UNITED STATES PATENT AND TRADEMARK OFFICE

APPLICATION NO.	FILING DATE	FIRST NAMED INVENTOR	ATTORNEY DOCKET NO.	CONFIRMATION NO.
10/822,101	04/08/2004	Agostino Tucciarone	AT-11	1706

Office Action Summary	Application No.	Applicant(s)	
	10/822,101	TUCCARONE ET AL.	
	Examiner	Art Unit	
	Mary Hoffman	3733

DETAILED ACTION

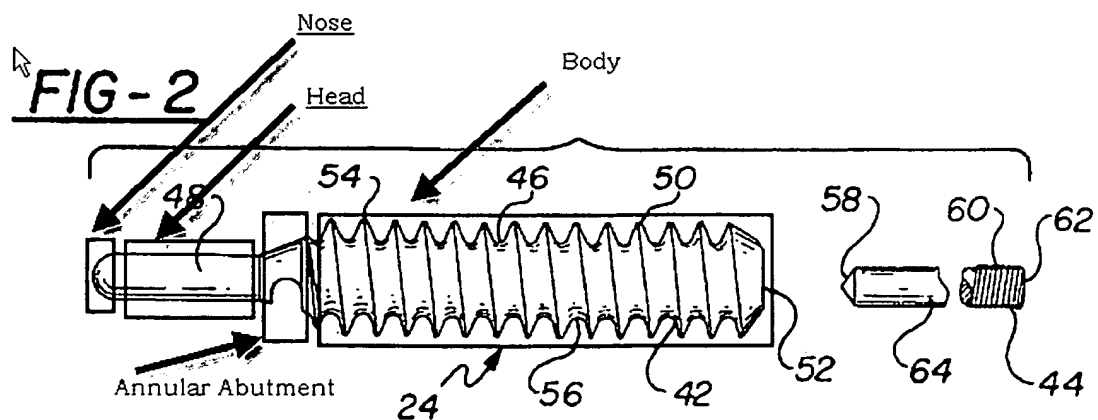
Howell et al. disclose a method of ACL graft ligament fixation comprising the steps of providing a transverse suspension device comprising a proximal body section defining a longitudinal axis, a head section extending along the longitudinal axis and protruding distally from the body section, the head section having a smaller diameter than that of the body section, and an annular abutment surface disposed between the head section and the body section wherein the abutment surface is substantially at an angle to the longitudinal axis (FIGS. 2-3); forming a femoral tunnel and forming a transverse tunnel intersecting the femoral tunnel (FIG. 10); locating a graft loop in the femoral tunnel in such a manner that an open face of the loop faces an intersection

where the femoral tunnel intersects the transverse tunnel FIGS. 11-12); passing at least a part of the head section of the transverse suspension device through the graft loop via the transverse tunnel until the head section contacts a recess formed in an opposite wall of the femoral tunnel wherein the abutment surface urges the graft against the opposite wall (FIG. 14). A guidewire is advanced under observation with a viewing device, specifically an arthroscope (col. 6, lines 37-53). The recess is formed with a dilator tool (ref. #124). The transverse suspension device is cannulated. The transverse tunnel is drilled to intersect and not cross the femoral tunnel. The body section comprises external threads. The device includes a nose section distal to and distinct from said head section and having a reduced diameter as compared to said head section, said nose section extending along said longitudinal axis, and an annular abutment surface distinct from said head section and disposed between said head section (see marked up figure below). The angle is about 90 degrees and the head section has a substantially constant diameter.

Applicant argues that the device of Howell et al. does not show a nose section, a head section, an abutment surface, and a proximal body section. As shown in the above marked up figure, the Howell et al. reference does disclose these features. It is noted that the recitation "distinct" is not sufficient to distinguish the current invention from the prior art, as one of the definitions of distinct is "distinguished as not being the same; not identical; separate" [Dictionary.com] and the Howell reference clearly shows this.
